**HOUSE SUB PANEL: The sub breaker panel was an exterior 125 Amp Cutler Hammer box with 60 Amp main disconnects. The service entrance conductors were #4 copper conductors. The interior wiring to the house was copper. The branch circuits were rated as follows:**

**GARAGE SUB PANEL:** The breaker panel was an interior 125 Amp Cutler Hammer box with 60 Amp main disconnects. The interior wiring to the structure was copper. The branch circuits were rated as follows:

E3807.1 Enclosures for switches or overcurrent devices.

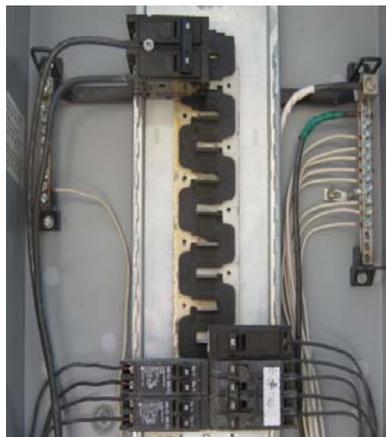
**The panel appeared to be over-filled. Electrical components and conductors can fill an enclosure within strict limitations on the area used by the appliances. The flow of electricity generates heat and there must be ample air in which to diffuse the heat. The area limitations should be confirmed by an electrician or other areas created for splicing the conductors.**

Enclosures for switches or overcurrent devices shall not be used as junction boxes, auxiliary gutters, or raceways for conductors feeding through or tapping off to other switches or overcurrent devices, except where adequate space for this purpose is provided. The conductors shall not fill the wiring space at any cross section to more than 40 percent of the cross-sectional area of the space, and the conductors, splices, and taps shall not fill the wiring space at any cross section to more than 75 percent of the cross-sectional area of that space.

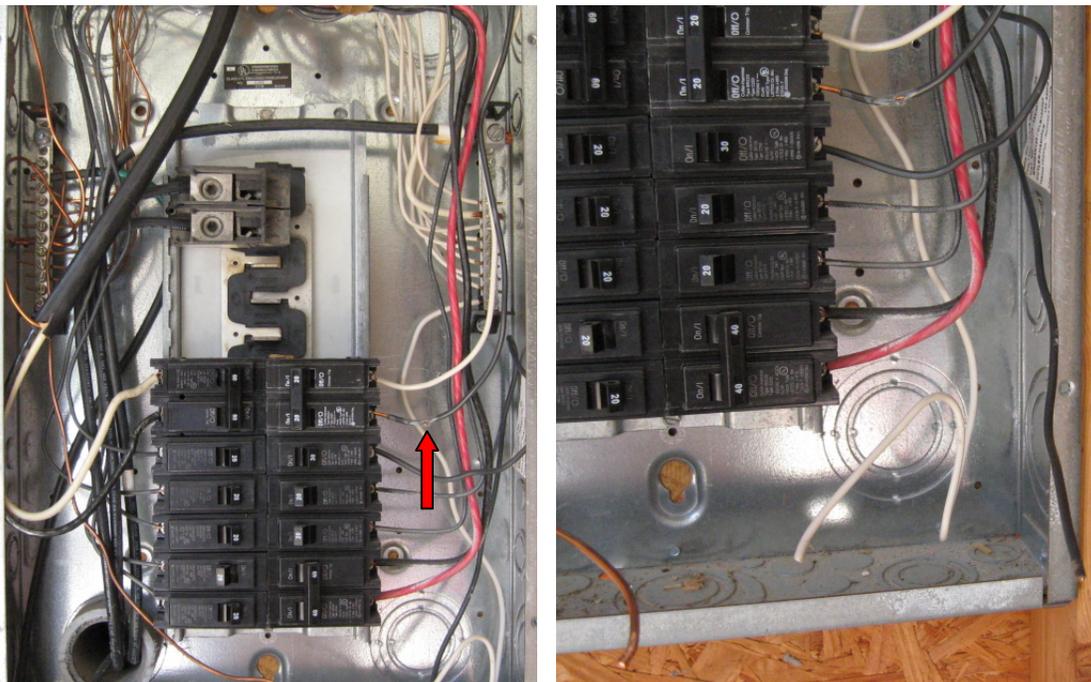
**The circuits were not properly labeled or identified in the breaker panel. As the circuits were not identified, it could not be determined if the circuits were properly sized for the listed appliances. Over sizing on any appliance is a recognized fire hazard. The National Electric Code, Section 408.4, states that identifying circuits as 'bedrooms or wall outlets or light switches' is not adequate. Labeling must be specific as to**

which appliances are to be protected by the over current device. The circuits should be rated and certified by a competent electrician according to the listings of the appliances.
